ADDENDUM #3

PROJECT: Rapid Valley Elementary School Addition and Remodel
DATE: March 16, 2026
BID DATE: March 19, 2026 at 2:00pm MST

PROJECT ADDENDUM NO. 03

ADDENDUM NO. 3 - MECHANICAL

DATE: **03.02.2026** SHEET NO:
PROJECT NO: **S105**
2025-198

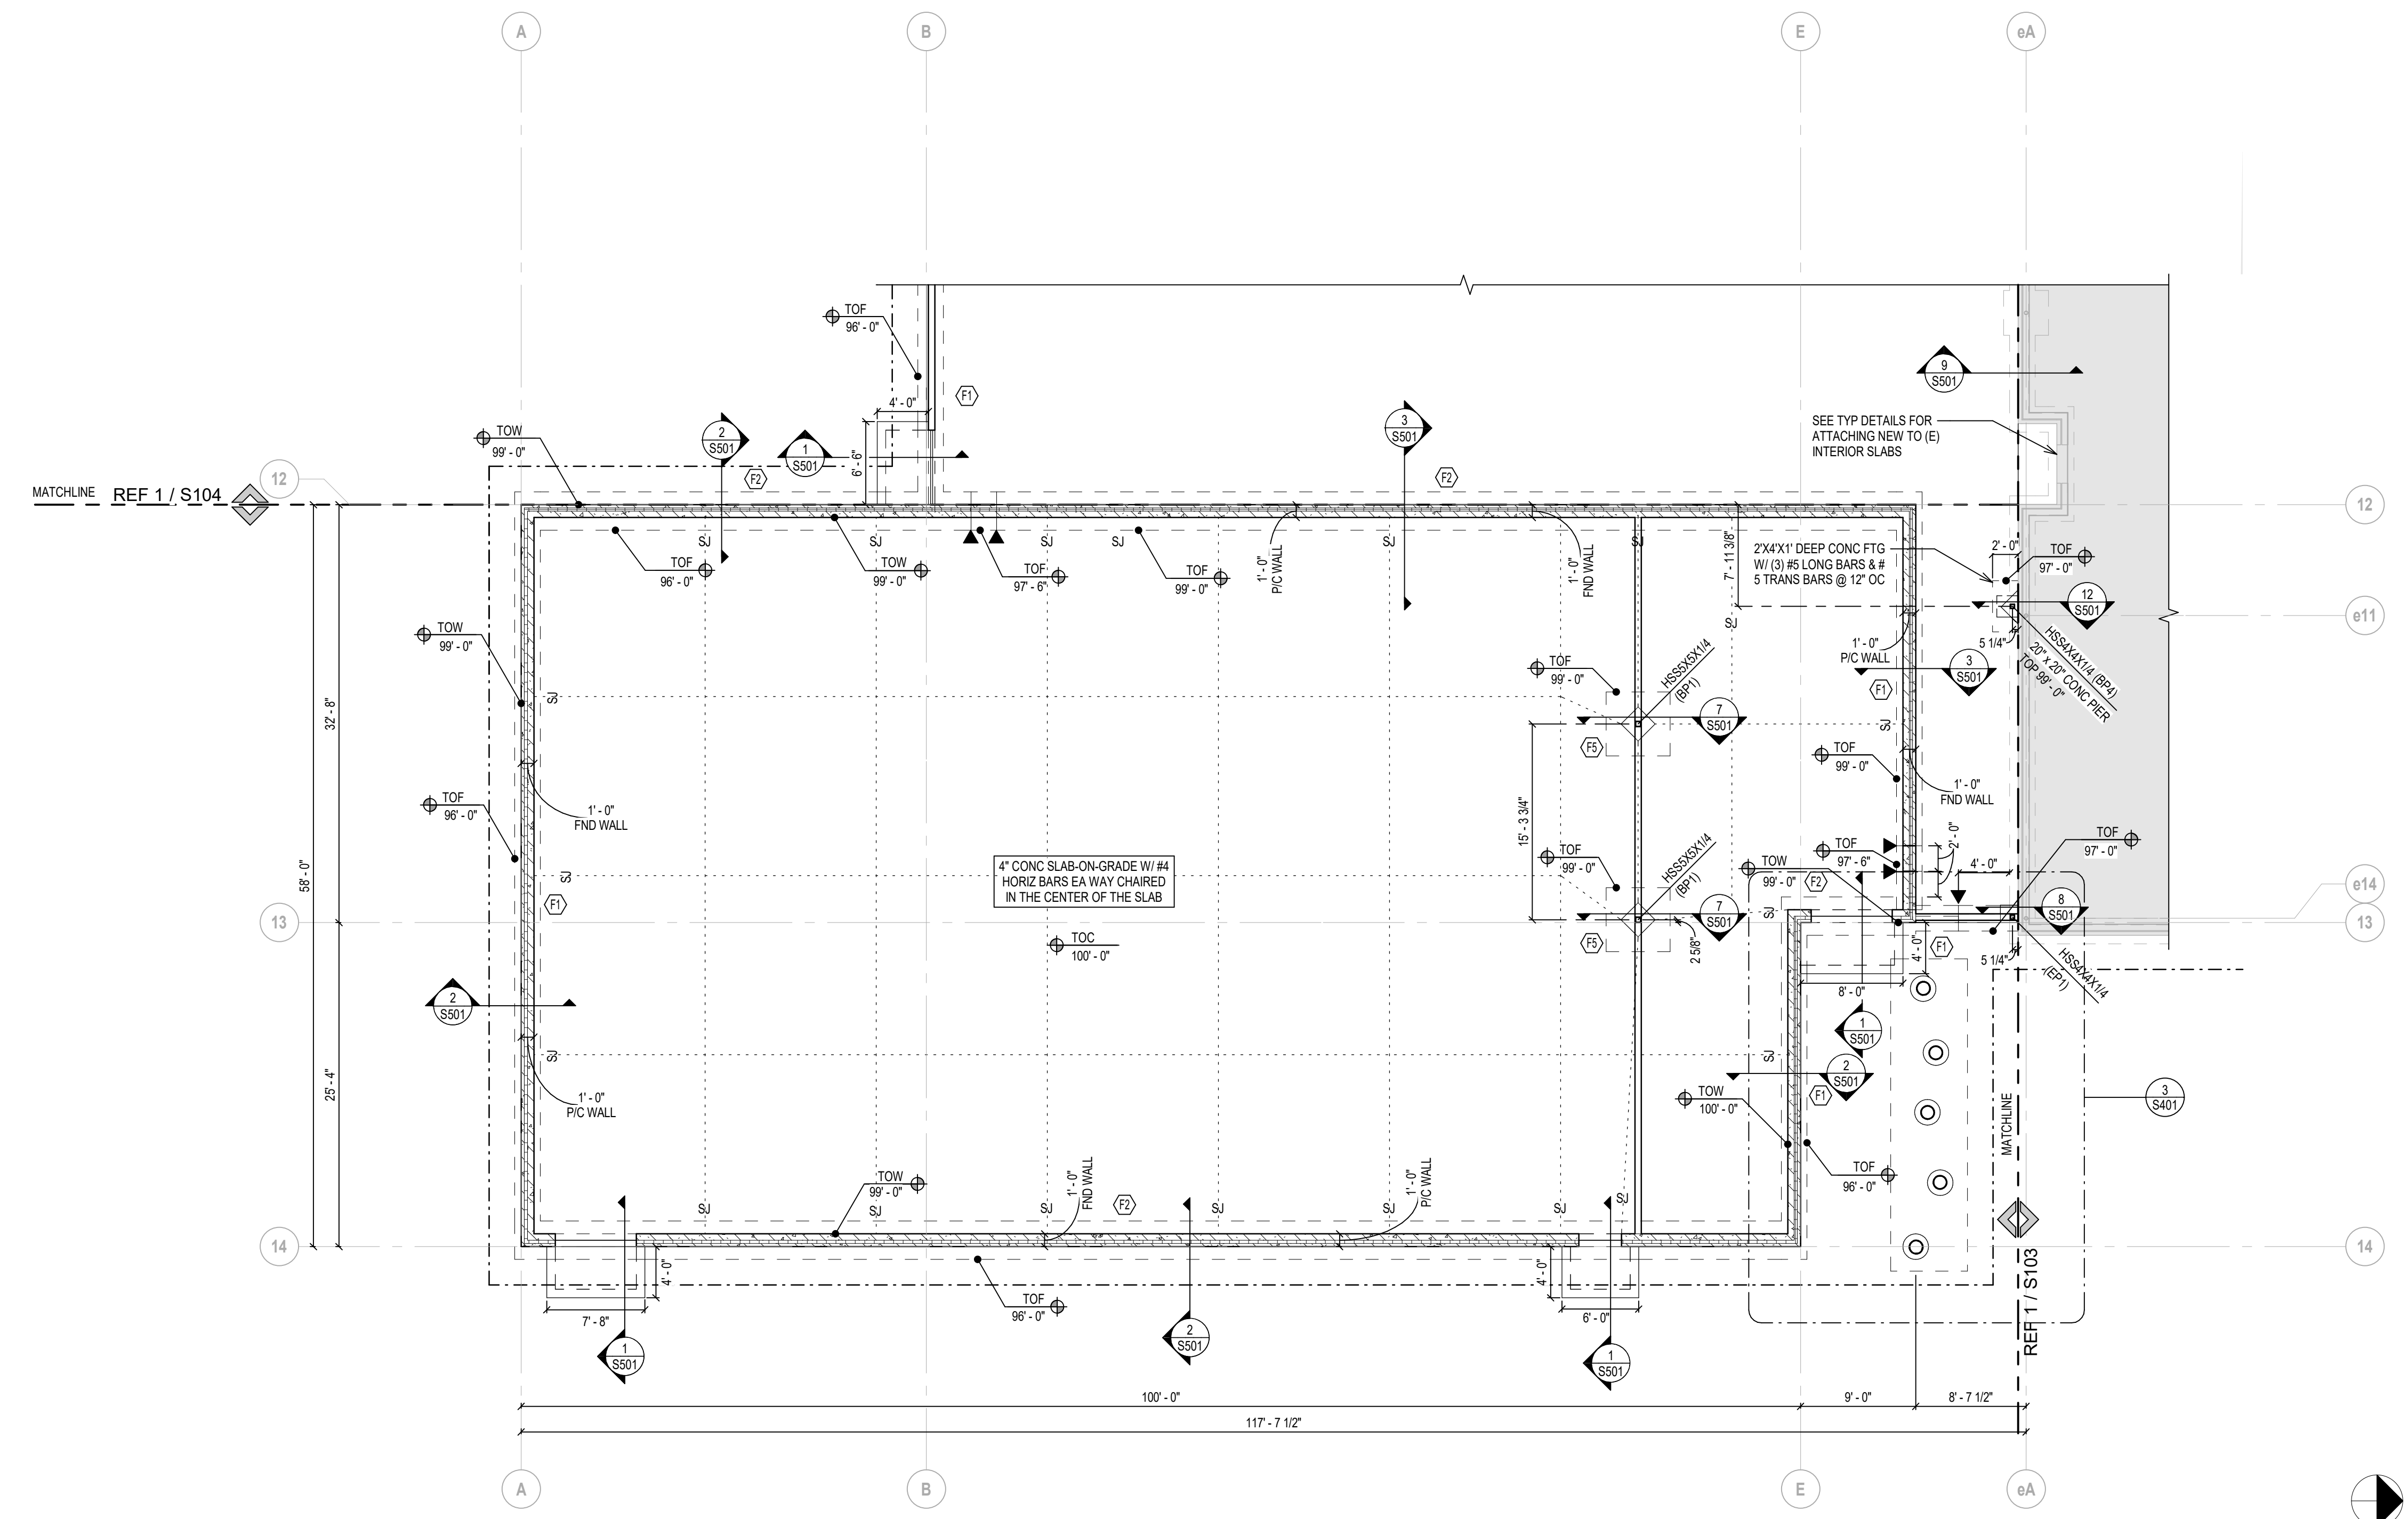
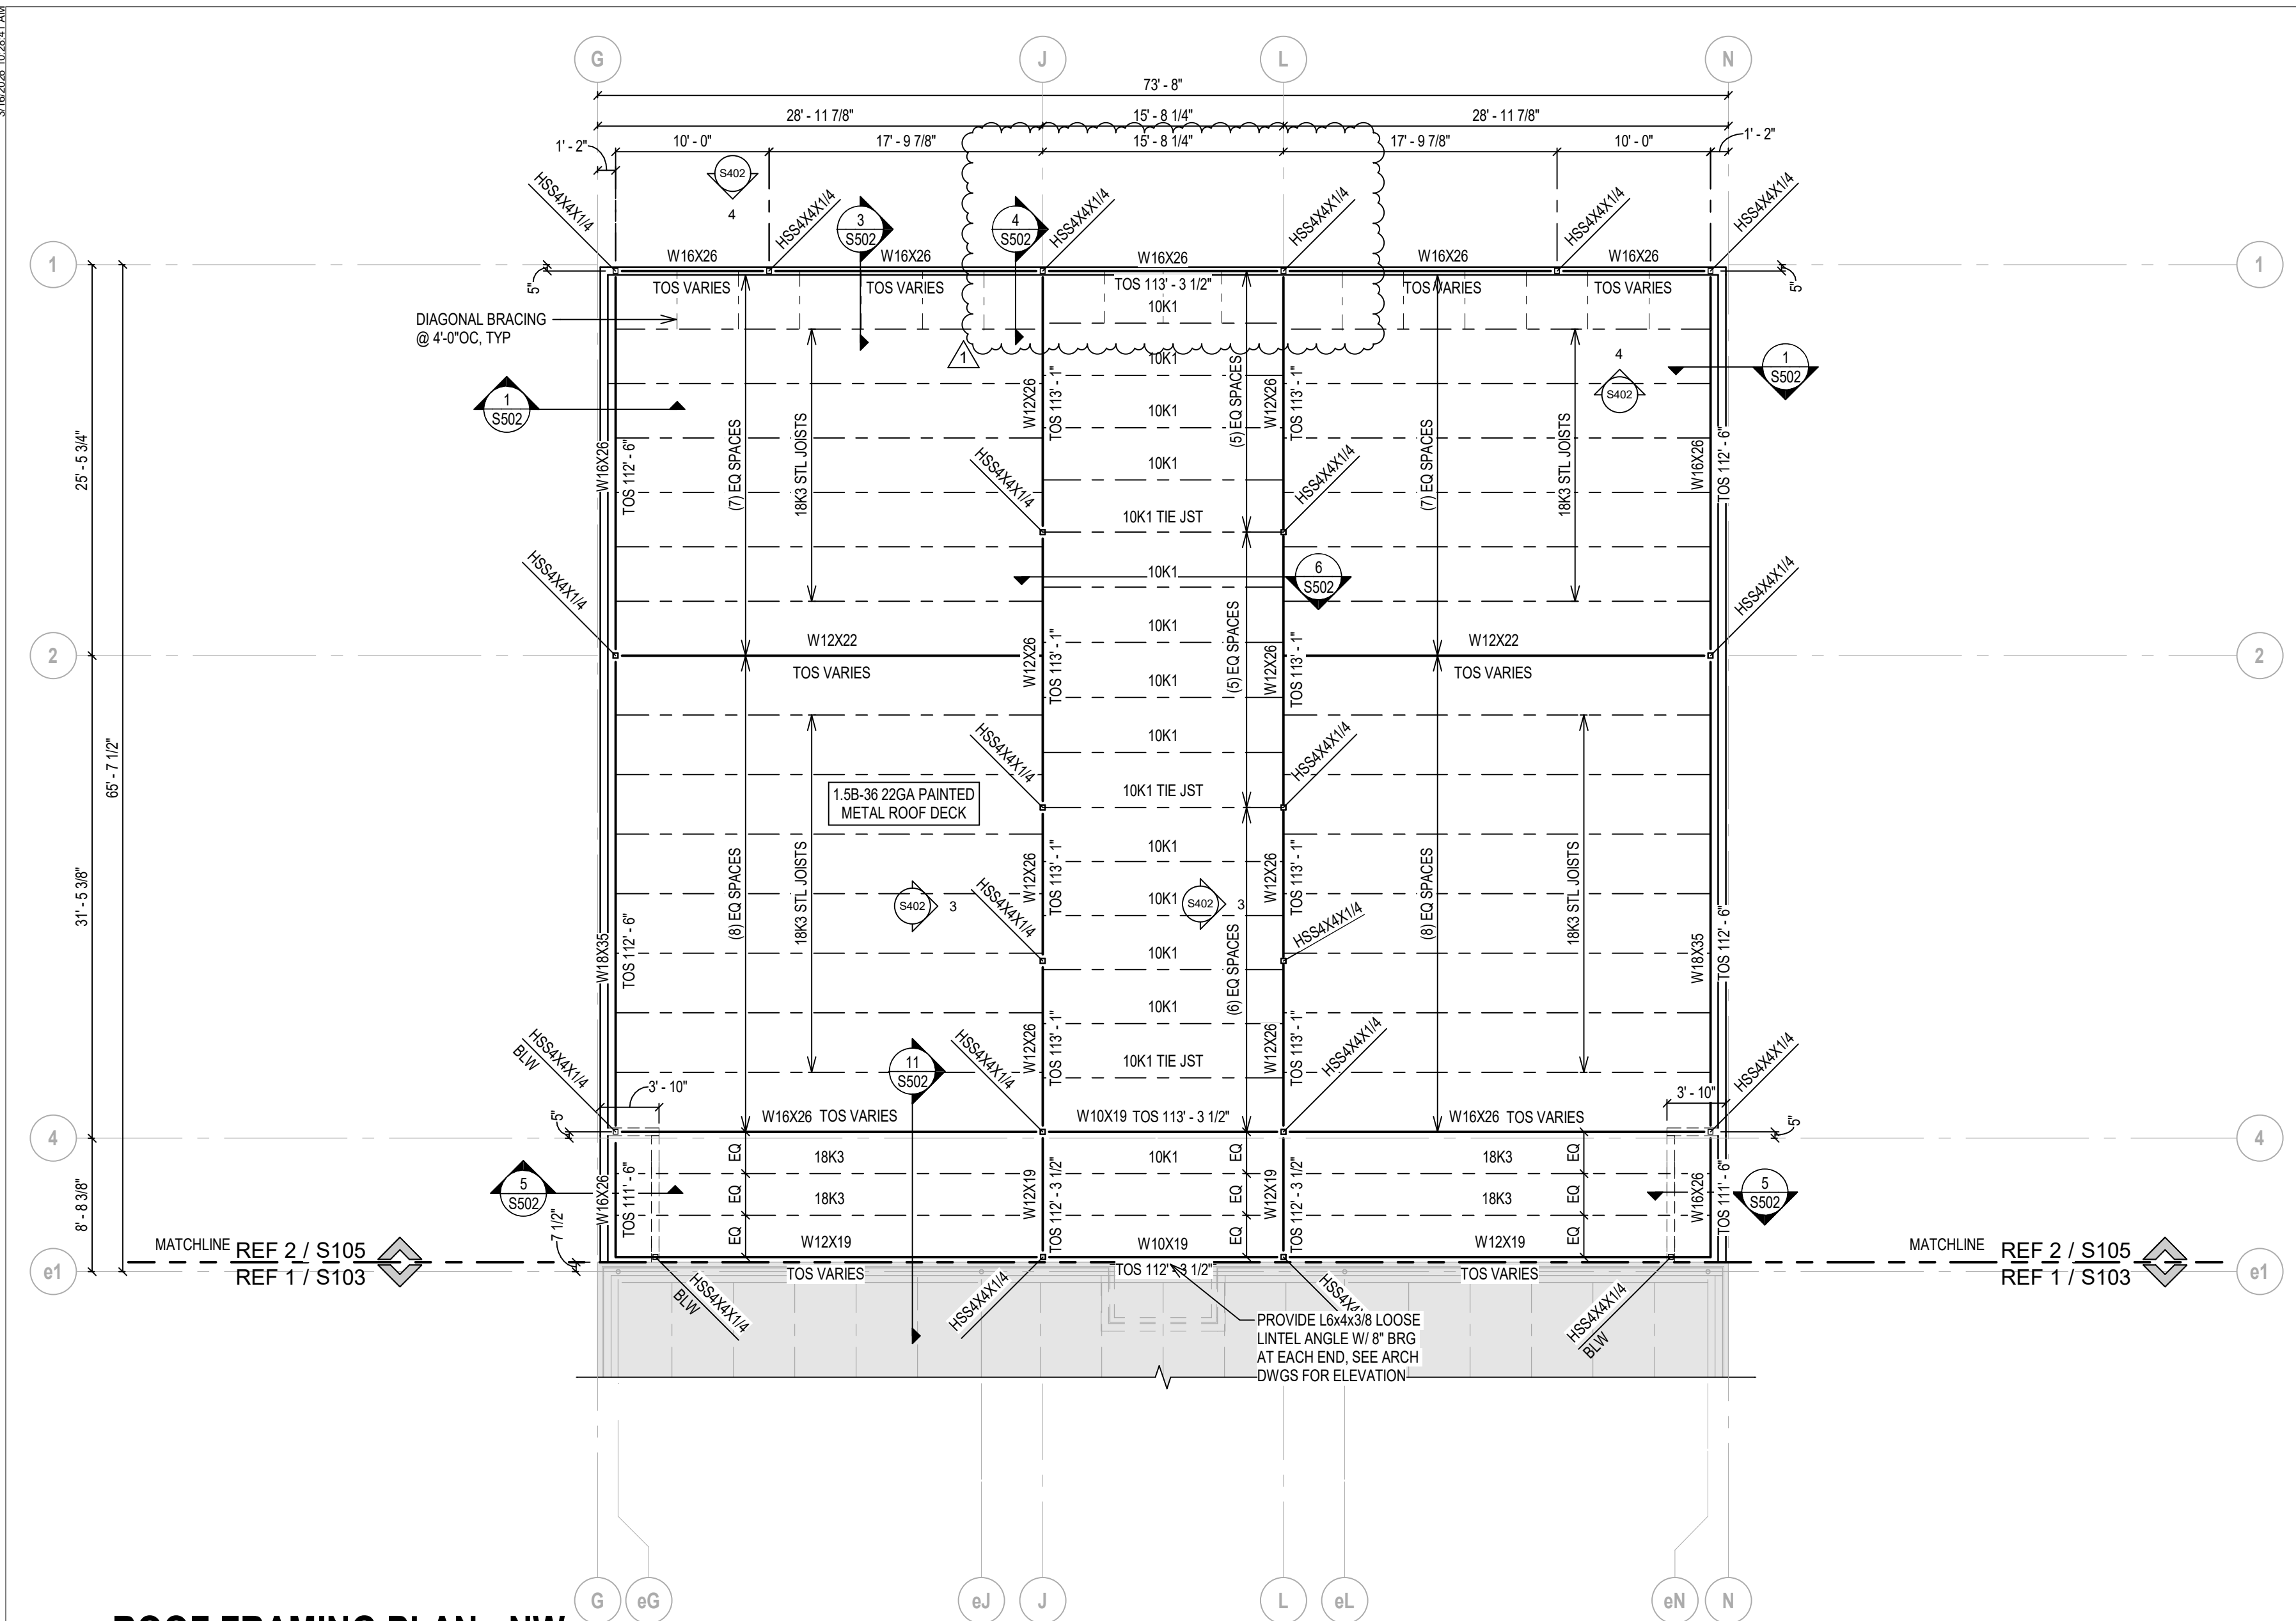
- Construction Documents
 - ◆ SHEET S105
 - i. Column along Gridline 1 between J & L was moved to Gridline J and additional column was added to Gridline L.
 - ◆ SHEET S109
 - i. Roof Plan Notes – Entry Canopy was added to the steel decking note.
 - ◆ SHEET S110
 - i. Column along Gridline 1 between J & L was moved to Gridline J and additional column was added to Gridline L.
 - ii. Beam line along gridline 1 was adjusted.
 - iii. Roof Plan Notes – Entry Canopy was added to the steel decking note.
 - ◆ SHEET S111
 - i. Roof Plan Notes – Entry Canopy was added to the steel decking note.
